Renovation of the roof - Building A1

Correctional Service Canada
Complex Sainte-Anne-des-Plaines

Architecture project no: 112411
Client project no: 343-2534

ARCHITECTURE ADDENDUM A01

Title: DRAWING MODIFICATIONS	Drawn by: EG	Date: 2016.11.15	Project No. 112411	240-01
	Approved by: SA	Scale: AUCUNE	343-2534

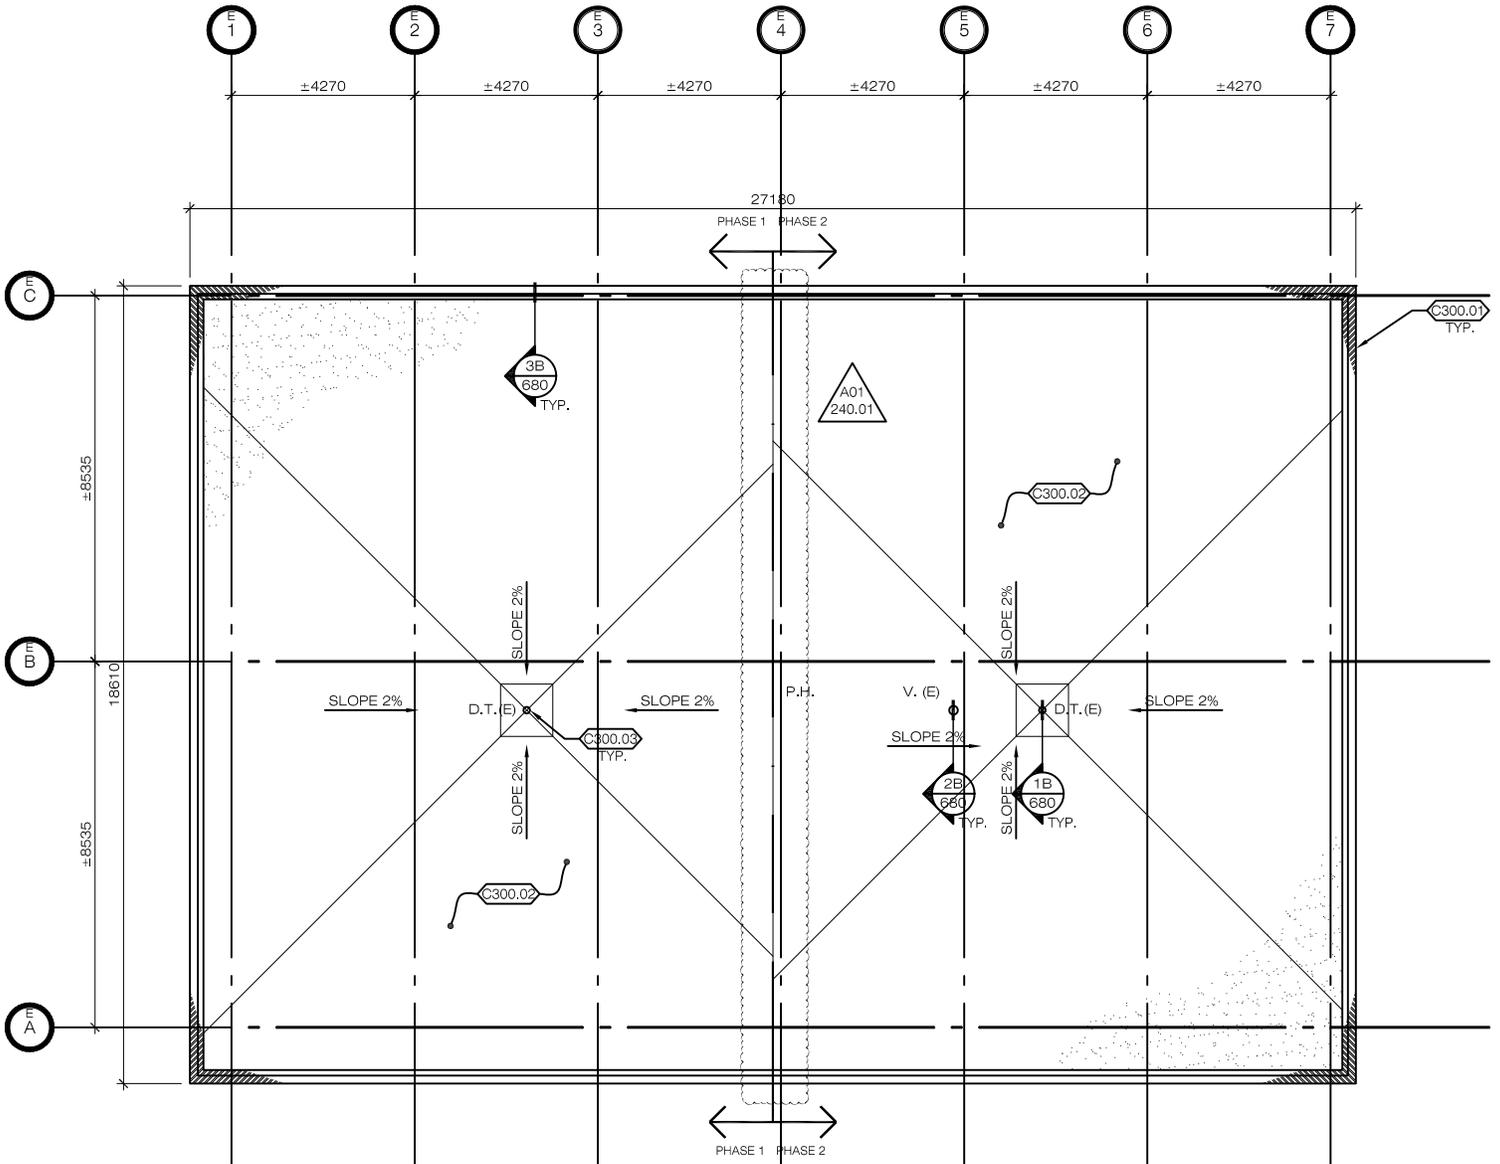
Item 240.01 Eliminate the basin separator, as shown in drawing 240-01 attached.

Title: DRAWING MODIFICATIONS	Drawn by: EG	Date: 2016.11.15	Project No. 112411	680-01
	Approved by: SA	Scale: AUCUNE	343-2534

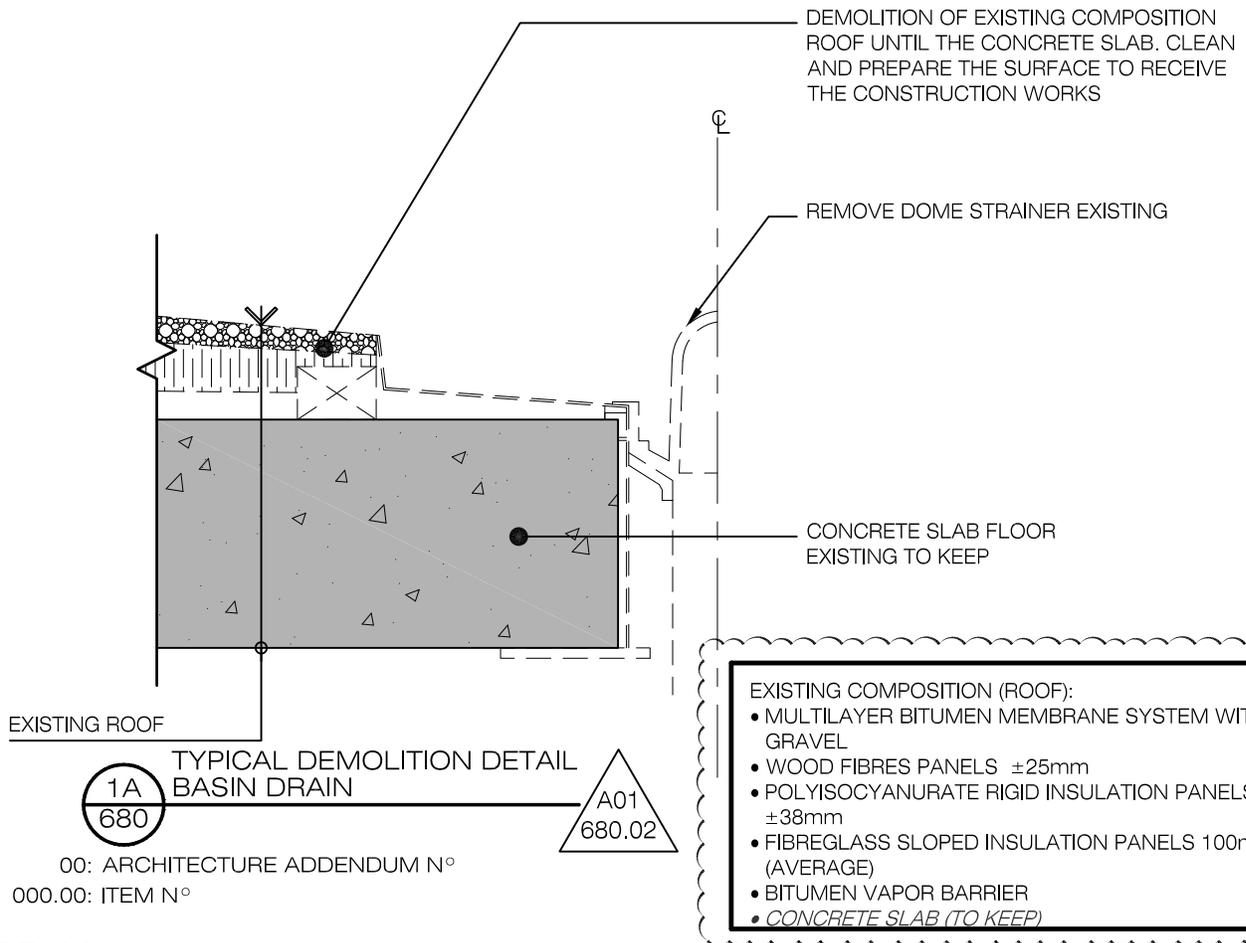
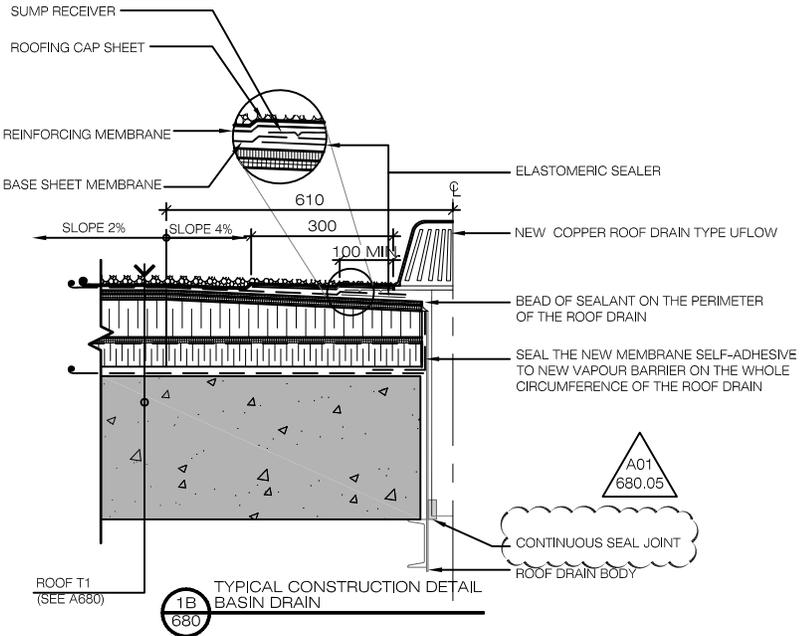
Item 680.01 Replace the description of roofing T1, as shown in drawing 680-01.

Item 680.02 In detail 1A/680, add the description of the existing composition (roof), as shown in drawing 680-01.

Item 680.05 Modify detail 1B/680, as shown in drawing 680-01 attached.

DESCRIPTION T1 (TAPERED INSULATION)		
MATERIAL	THICKNESS (mm)	THERMAL RESISTANCE (RSI)
-WHITE MARBLE	13	0.01
-OUTSIDE LAYER OF AIR	N/A	0.03
-ROOFING CAP SHEET (ELASTOMER MEMBRANE)	N/A	0.03
-BASE SHEET MEMBRANE (ELASTOMER MEMBRANE)	N/A	0.03
-FIRE RESISTANT ROOF PANELS		
-HIGH STRENGTH COATED	13	0.33
-TAPERED POLYISOCYANURATE INSULATION	38 MIN	1.14
-POLYISOCYANURATE INSULATION	75	2.62
-VAPOUR BARRIER	0.905	0.022
-CONCRETE SLAB FLOOR EXISTING	±305	0.39
	±431	4.60

- MULTILAYER BITUMEN MEMBRANE SYSTEM WITH GRAVEL
- WOOD FIBRES PANELS ±25mm
- POLYISOCYANURATE RIGID INSULATION PANELS ±38mm
- FIBREGLASS SLOPED INSULATION PANELS 100mm (AVERAGE)
- BITUMEN VAPOR BARRIER
- CONCRETE SLAB (TO KEEP)

Title: DRAWING MODIFICATIONS	Drawn by: EG	Date: 2016.11.15	Project No. 112411	680-02
	Approved by: SA	Scale: AUCUNE	343-2534

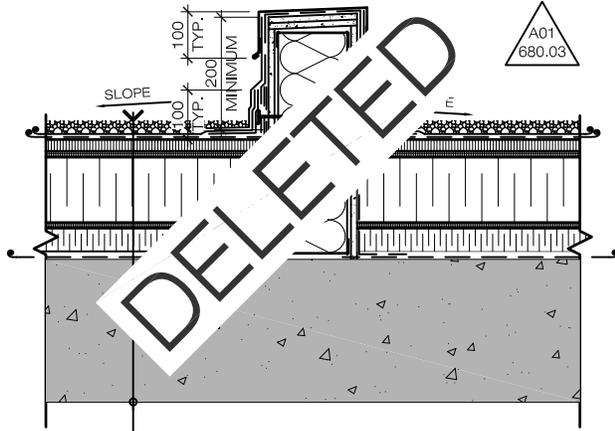
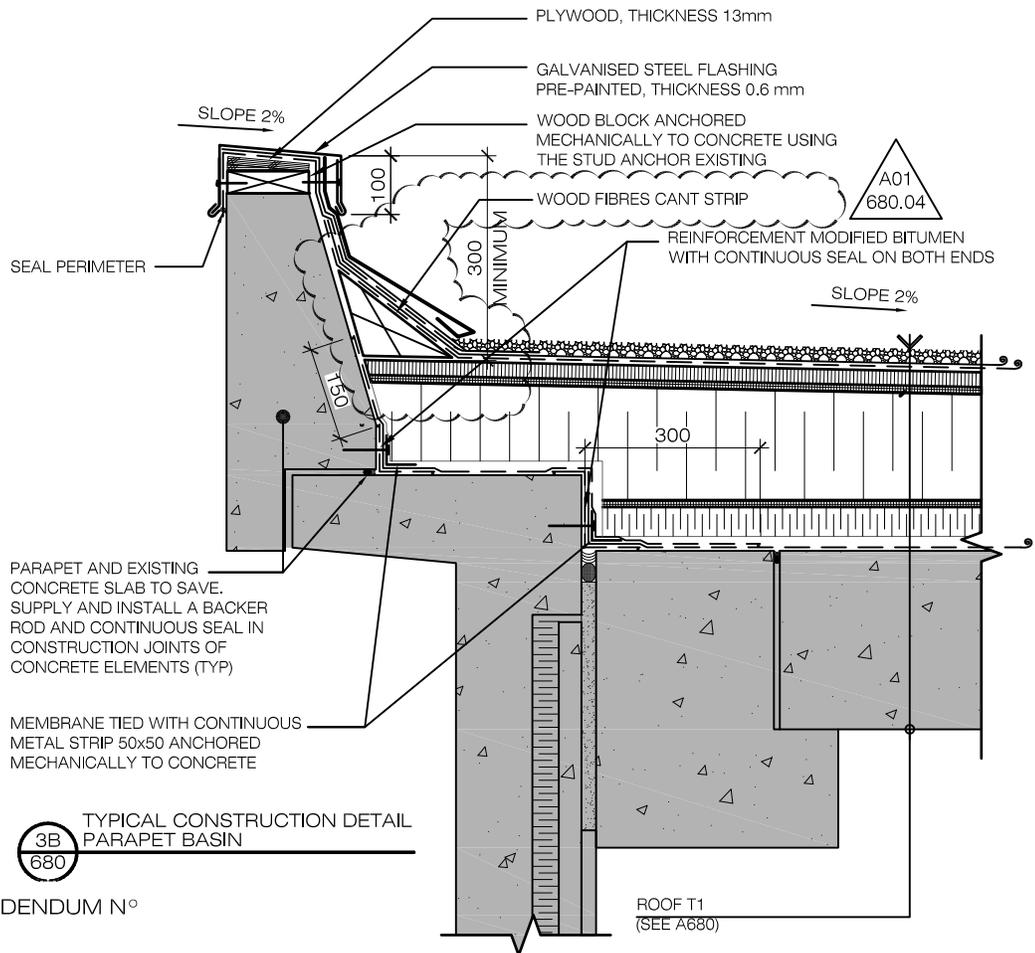
Item 680.03 Eliminate the detail of basin separator 4/680, as shown in drawing 680-02.

Item 680.04 Add a wood fibres cant strip in detail 3B/680, as shown in drawing 680-02.
